FINAL SAFETY EVALUATION REPORT

TRANSNUCLEAR, INC.

STANDARDIZED NUHOMS® HORIZONTAL MODULAR STORAGE

DOCKET NO. 72-1004

Figure 4.1 69BTH DSC Boundary Temperatures along Top of DSC Derived from Results of STAR-CD model of 32PTH1 in HSM-H

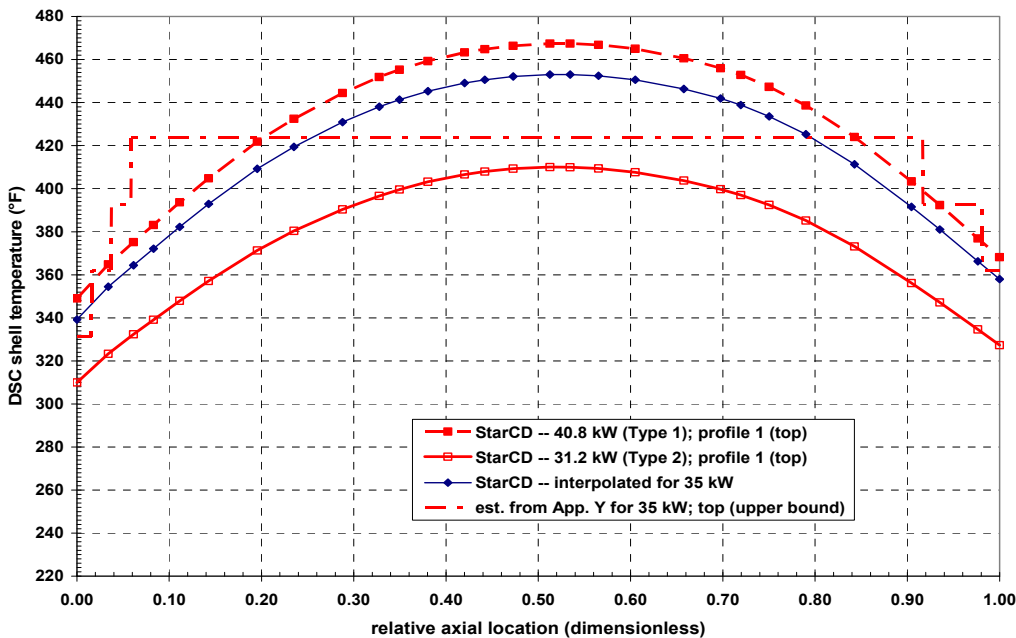
reported in Appendix Y of the FSAR for the 69BTH in the HSM-H are compared in Figure 4.1 to the DSC shell temperatures at the corresponding location obtained with the STAR-CD model of the 32PTH1 (at 40 kW) in the HSM-H. Similar plots are shown in Figures 4.2 and 4.3 for the temperature profiles along the side and bottom of the surface of the horizontal DSC within the HSM-H. This comparison shows that the temperature profiles used in the applicant's analyses are somewhat flattened axially, and so do not capture the axial peak temperatures on the DSC shell, but have a more conservative radial distribution, with higher temperatures on the sides and bottom of the DSC shell. Based on this comparison, the staff concluded that the surface temperatures of the 69BTH DSC with decay heat of 35 kW are effectively bounded by the DSC temperatures reported for the 32PTH1 DSC with decay heat of 40.8 kW. Similarly, the DSC temperatures of the 37PTH DSC with decay heat of 30 kW are bounded by the surface temperatures reported for the 32PTH1 DSC with decay heat of 31.2 kW. For these decay heat loads, ambient temperatures, and the HSM-H configuration, the staff determined that the thermal analyses of the 32PTH1 DSC in the HSM-H can be used to bound the thermal analyses of the 69BTH DSC and the 37PTH DSC for storage conditions in the HSM-H.

Figure 4.2 Temperature Profile Line from Top to Bottom of 69BTH DSC in Horizontal Storage

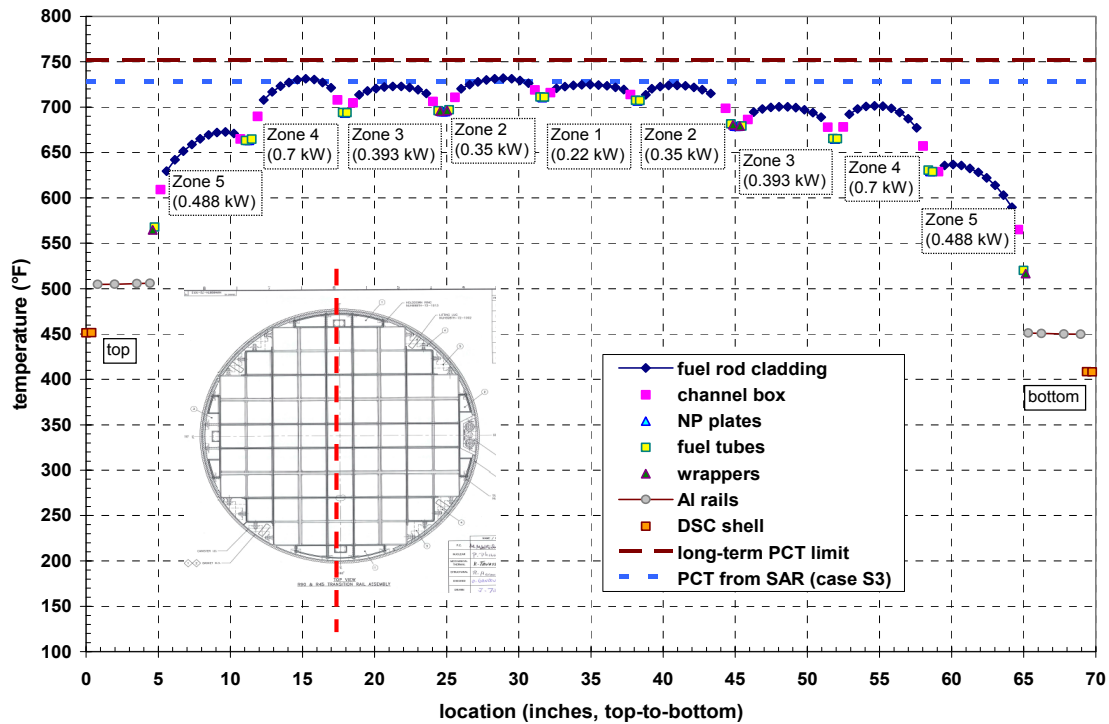
The component temperatures (including fuel rod cladding) along the line from top to bottom of 69BTH DSC through the location of peak clad temperature, determined in the staff's confirmatory evaluation are displayed in Figure 4.2. The calculated PCT within the 69BTH for each HLZC at maximum decay heat load is displayed in Table 4.20. Based on these results, the staff has confirmed that the 69BTH DSC provides adequate heat removal capacity under storage conditions.

Figure 4.3 Summary of Thermal Analysis Cases S3, S4, S5, T6, T7, T9, T12, and T13 for 69BTH DSC and 32PTH1 DSC under Storage and Transfer Conditions

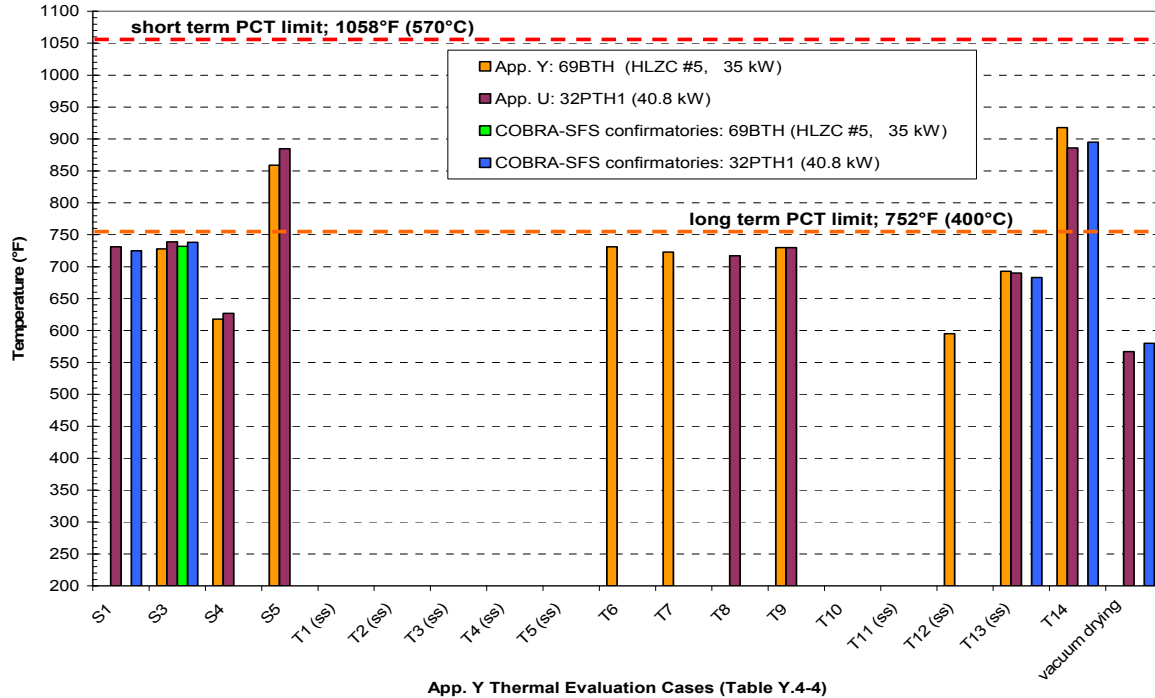
Figure 4.3 displays a summary of the results of the applicant’s thermal analysis of cases S3, S4, S5, T6, T7, T9, T12, and T13 for the 69BTH DSC and S1, S3, S4, S5, T8, T9, T13, and T14 for the 32PTH1 DSC, as well as the staff’s confirmatory evaluation of cases S3 for the 69BTH DSC and S1, S3, T13, and T14 for the 32PTH1 DSC. Based on the PCTs predicted from the applicant’s analysis, and the staff’s confirmatory evaluation of the 69BTH DSC and comparison with the PCTs calculated from the 32PTH1 DSC, the staff confirmed that the PCTs of 69BTH DSC are either bounded by the PCTs of 32PTH1 or below the temperature limits of 400°C (752°F) for normal storage and transfer conditions and 570°C (1058°F) for off-normal and accidental storage and transfer conditions. The staff confirmed that the PCTs for the bounding heat load cases of S1, S3, and S5 for normal, off-normal, and accidental storage and T9, T13, and T14 for normal, off-normal, and accidental transfer meet the required temperature limits, as shown in Figures 4.2 and 4.3.
